ENVIRONMENTAL REVIEW TEAM REPORT

OLD FARM HILL SUBDIVISION NEWTOWN, CT

**OLD FARM HILL SUBDIVISION
NEWTOWN, CT
JULY 1984**

This report on the proposed "Old Farm Hill Subdivision" was prepared at the request of the Newtown Planning and Zoning Commission.

FIGURE 3 PROJECT PHASING

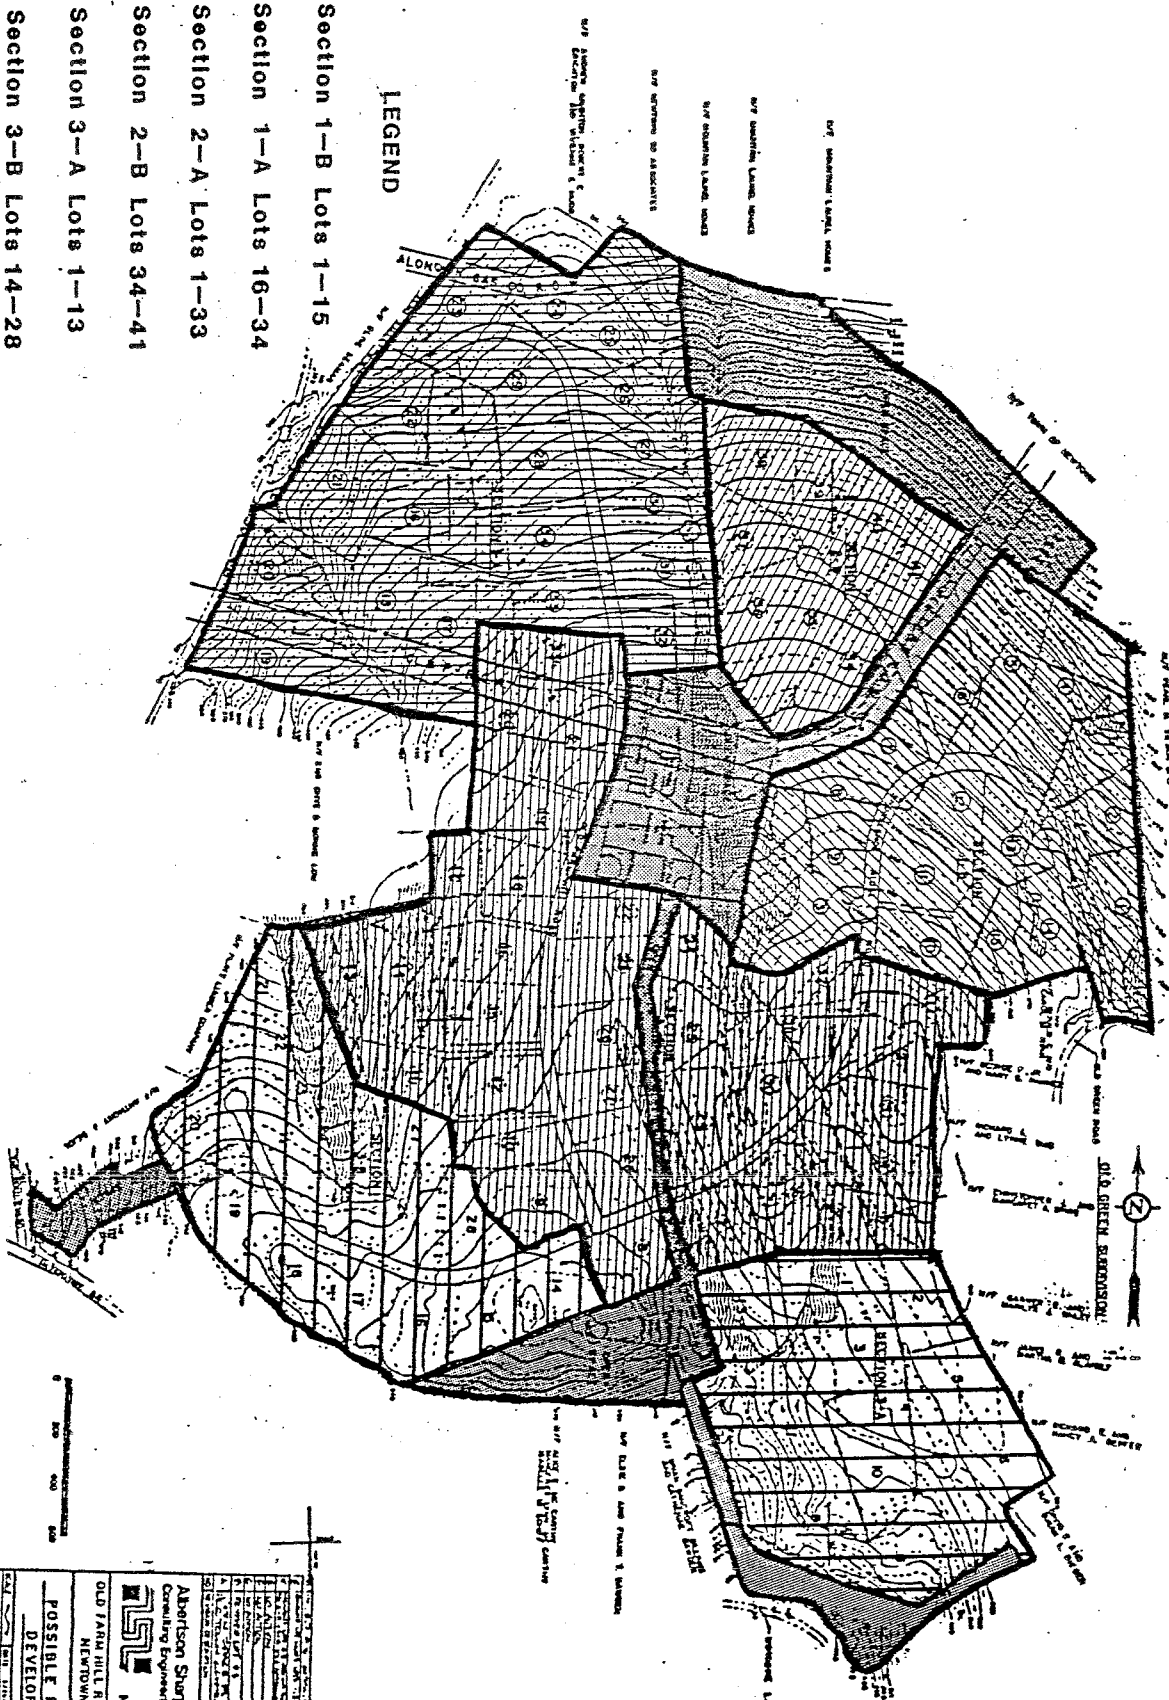
As shown in Figure 3, the project is proposed to be completed in six separate phases. Phase I-B of the project (15 lots in the northeastern corner of the tract) has already been approved by the town and is under construction. Phase I-A (22 lots in the northwestern corner) has been submitted to the Inland Wetlands Commission for approval and is expected to be received by the Planning and Zoning Commission in the near future.

Although no specific soil test data was available on the remaining subdivision sections, it appeared obvious that on site disposal would be most critical in section 2-A. The limited slope of the Charlton, Paxton and Woodbridge soils will mean greater difficulty in controlling seasonal ground water problems. The hydraulic restrictions due to soil type, limited slope and infiltration of seasonal rainfall may be a severe problem on lots 9, 10, 12, 22 through 30 of Section 2-A. When individual subdivision lot soil testing is done in this area, provisions should be made to permit accurate determination of seasonal high ground waters through the forthcoming spring months. It may be necessary for the developer to install ground water control drains on certain lots to demonstrate how effective control of seasonal high ground water can be achieved. Any lot on which the ground water remains less than 18 inches from the surface of the ground for a month or more during the wet time of the year would be classified unsuitable in accordance with the Public Health Code.

In summary, development of the Old Farm Hill property as proposed by the design engineer does appear feasible. The most marginal section, 2-A, will present the greatest problems in development due to soil types, limited gradient and the associated problems in development due to soil types, limited gradient and the associated ground water/surface water problems. The remaining sections 2-B, 3-B, and 3-A were considerably drier and provided acceptable slope normally required for effective ground water control. It is probable to assume State Health Department staff will provide technical assistance to the Newtown Health Department in reviewing specific soil test data and subdivision proposals as individual sections are submitted to town agencies for review and approval.

The road layout appears to be consistent with the town's subdivision regulations. Lots 23 and 24 in Section 1-A are awkwardly divided by the gas line r.o.w. and lot 13 in Section 2-A appears not to meet the "minimum square" requirement of the zoning regulation. Also, a few rear lots have access driveways of 350 to 700+ feet, which could cause problems if they are impassable to emergency vehicles. Careful review of every lot will be called for in view of the drainage and septic system concerns on the site. The drainage review should also take into consideration the fact that the Plan of Development indicates that the area of Hanover Rd./Echo Hill Rd. to the Forest Association property overlies a major aquifer.

FIGURE 4 WATERSHED BOUNDARY MAP

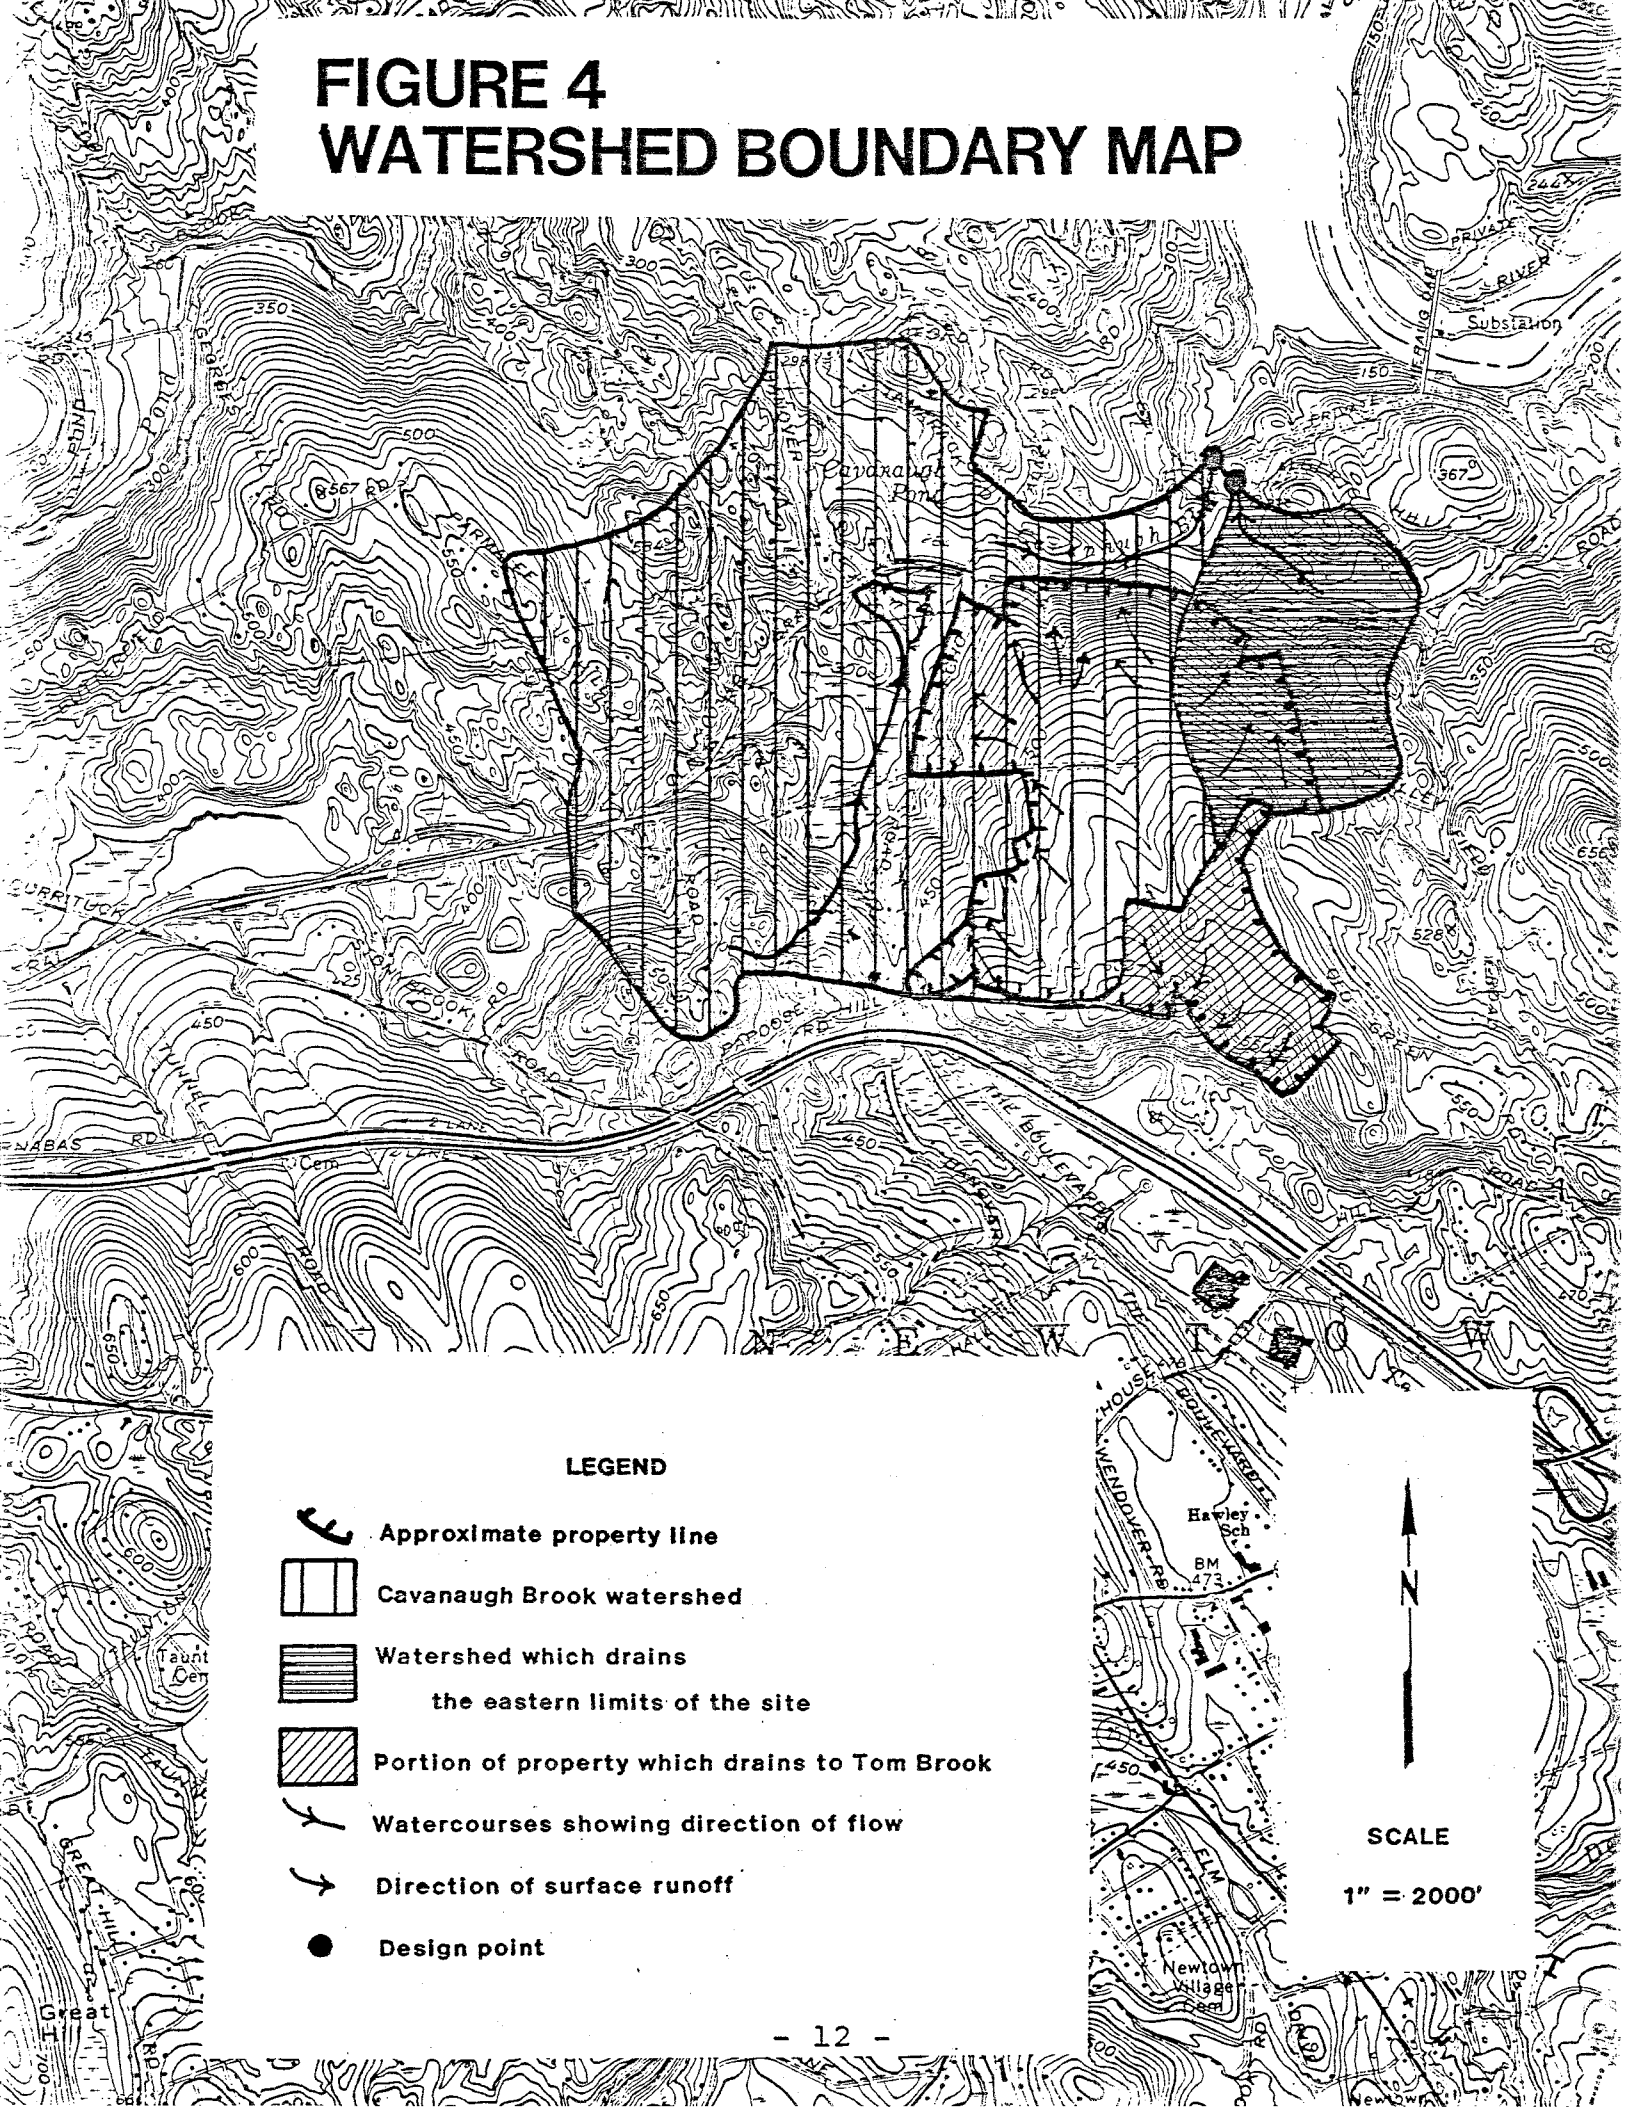
As shown in Figure 4, the site can be divided into three drainage areas. Surface runoff from the western and central portions, which consists of approximately 211 acres or nearly 70% of the site, lies within the watershed of Cavanaugh Brook. Once Cavanaugh Brook outlets from Cavanaugh Pond, which is north of the site, the Brook flows eastward for about 3,000 feet, ultimately discharging into the Housatonic River. Drainage in the eastern limits of the site is by an unnamed tributary of the Housatonic River north of the property. This tributary outlets into the Housatonic River at the same point of outflow as Cavanaugh Brook. The remaining + 63 acres in the southern part of the site lies within the watershed of Tom Brook. Tom Brook flows in a southeast direction parallel to I-84 and ultimately discharges into the Pootatuck River. Surface waters, and for the most part, groundwaters on the site flow generally downslope toward local discharge areas such as intermittent drainage channels. Water is then routed via these channels. As a result, land in these areas hold low potential for development and/or on-site sewage disposal systems.

Development of the site under present plans can be expected to increase the amount of runoff from the site for a given rainfall amount. These increases will result mainly from the conversion of permeable soils to impermeable surfaces such as roofs, paved roads and driveways, and from the removal of vegetation. The effects of added runoff from developed areas may lead to increased overland and stream-channel erosion and may increase the potential for flooding in downstream areas.

probably be greater in areas of more concentrated development and less in areas of lesser disturbance. Due to the increases in stormwater runoff volume which is expected to occur with the various phases of development of the parcel, it is recommended that a detailed stormwater management plan be prepared for this project for Town review. Special attention should focus on the effects of the development on downstream culverts as well as the proposed detention area which is to be located on the Newtown Forest Association property northwest of the site. The Town should consider requesting that either the town engineer or a consulting professional engineer review the final stormwater management plan as well as the drainage computations.

Prior to subdivision approval, consideration should be given to requiring the applicant to submit hydrological information on pre- and post development runoff volumes and peak flows from the property. Estimates should be provided for a 10, 25, 50 and 100 year design storm. Also, detailed design specifications for all stormwater control facilities should be submitted.

FIGURE 5 SOIL MAP

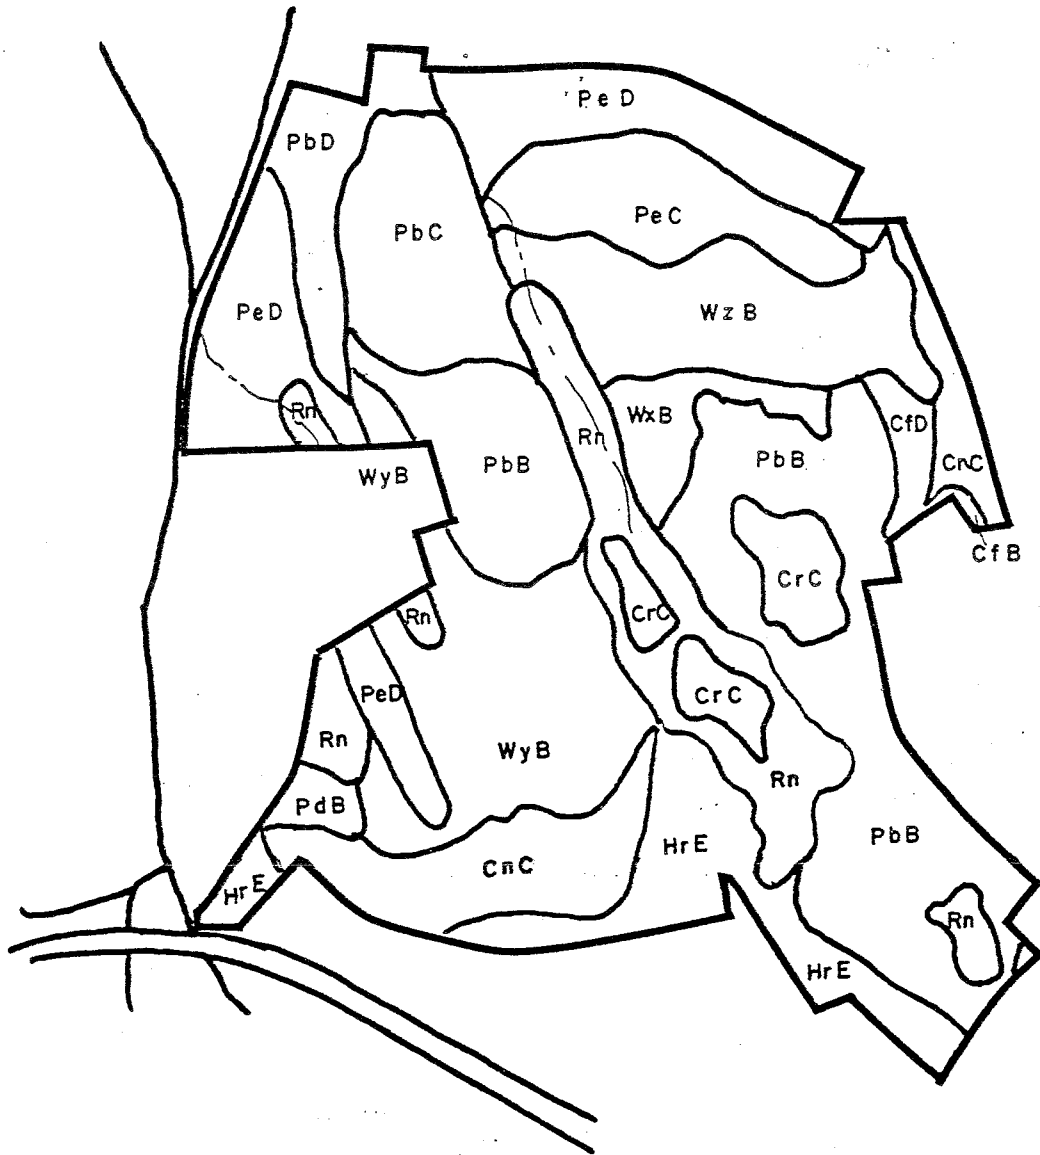
Development in areas designated as Rn (Ridgebury, Leicester, Whitman soils) on the soil map should be avoided if possible. Based on the site plan submitted to Team members on the review day, it appears the wetlands will be crossed in only one area of the subdivision. This wetland crossing is located

As shown on the accompanying soils map (see Figure 5), there are areas of wetland soils (Rn). These wetland soils lie principally along drainage channels and/or in perennial watercourses. These wetlands, especially those flatter, low-lying areas may act as a natural runoff retention basin, thereby reducing downstream flooding during storms. They also serve many other valuable hydrological functions such as trapping sediment from upstream areas and providing pollution control through biochemical processes. For these reasons, these areas should be left undisturbed where possible.

On this particular site perched water tables occur in all the hardpan soils at depths of less than 24 inches. All the hardpan soils have severe limitations for septic tank absorption fields. These soils cannot be used for absorption fields without special engineered designs and modification of the soils at the site. There are several reasons for this. Septic effluent must pass through unsaturated soil in order to be properly renovated. In cases where the perched water table occurs at shallow depths, proper renovation of the effluent does not occur. In addition, septic effluent will flow along the top of the hardpan layers since the hardpan is so slowly permeable. This may result in effluent surfacing downslope.

The site plan shows an area set aside for open space which may eventually be developed for active recreational use. This open space is located in the center of the parcel. This area has poor potential for playgrounds and other heavy foot traffic. Without drainage controls, the slow permeability of the hardpans, along with relatively high water tables will keep the playing fields soggy in the spring and fall as well as after heavy summer rains.

FIGURE 6 VEGETATION TYPE MAP

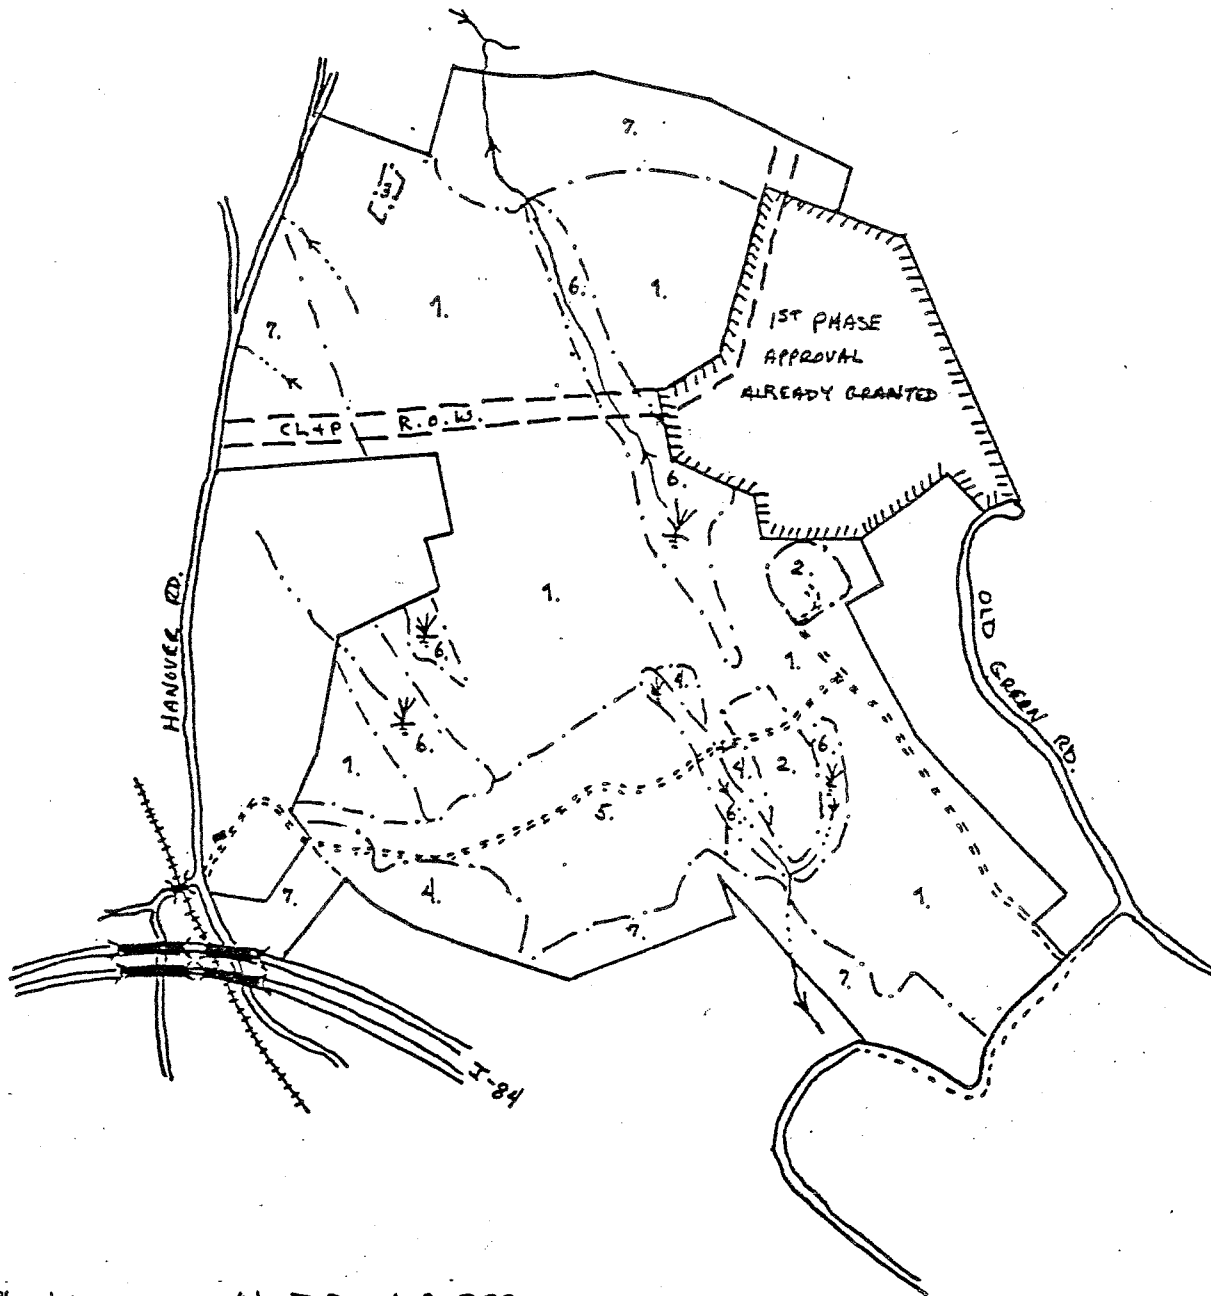
1) As soon as is practicable, a professional forester should be employed to mark and manage a thinning of types 1 and 5. Aesthetics should be the major concern, and the thinning should therefore be designed to remove the poorest quality stems. This would include: severely damaged trees; trees with very small crowns, large seams in the trunk, and obvious disease problems; and trees which are directly competing with more desirable, high vigor, healthy trees.

At the same time, a light thinning and pruning of the spruce in type 3 should be undertaken.
